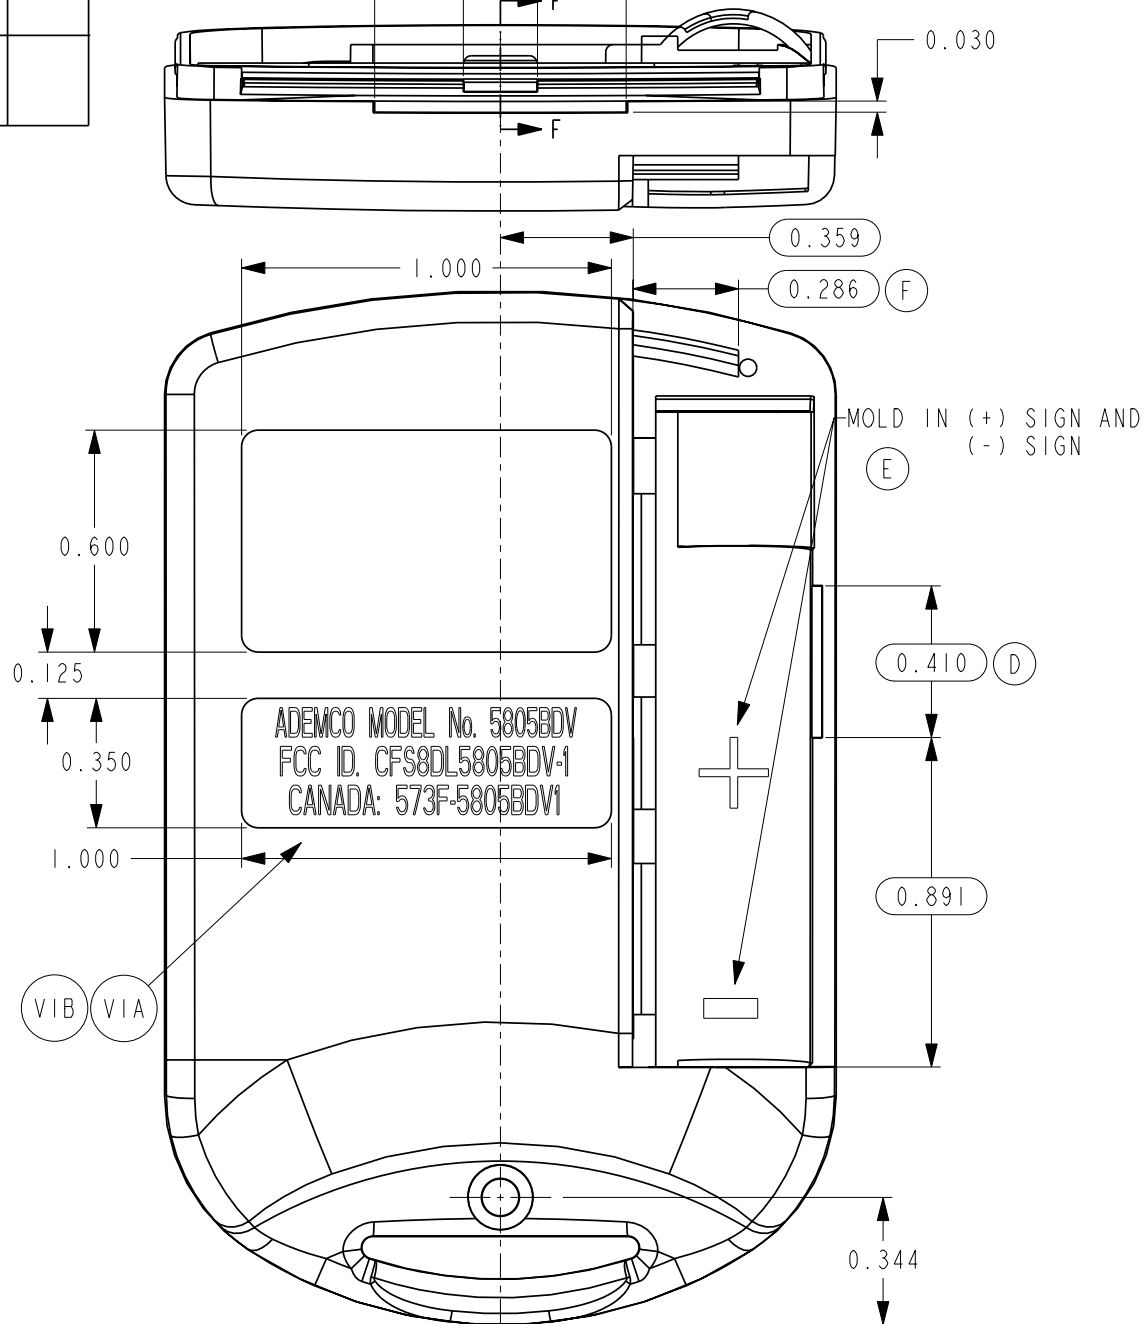
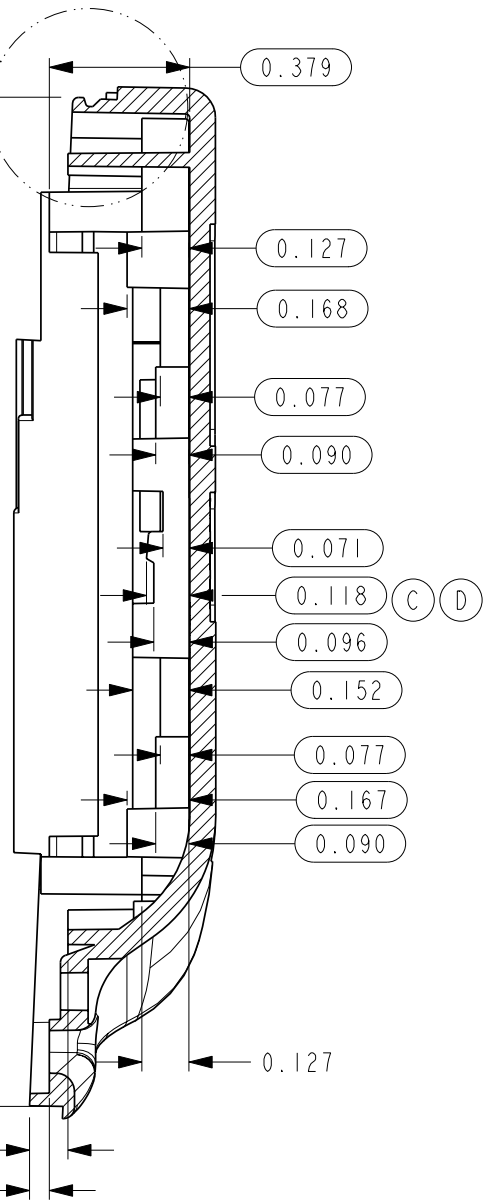
0.036 CHAMFER		
ED NOTE# 20. C3: ADDED Ø .047	FB	
PTH OF HOLE TO THRU HOLE		
M. A4: .286 WAS .300
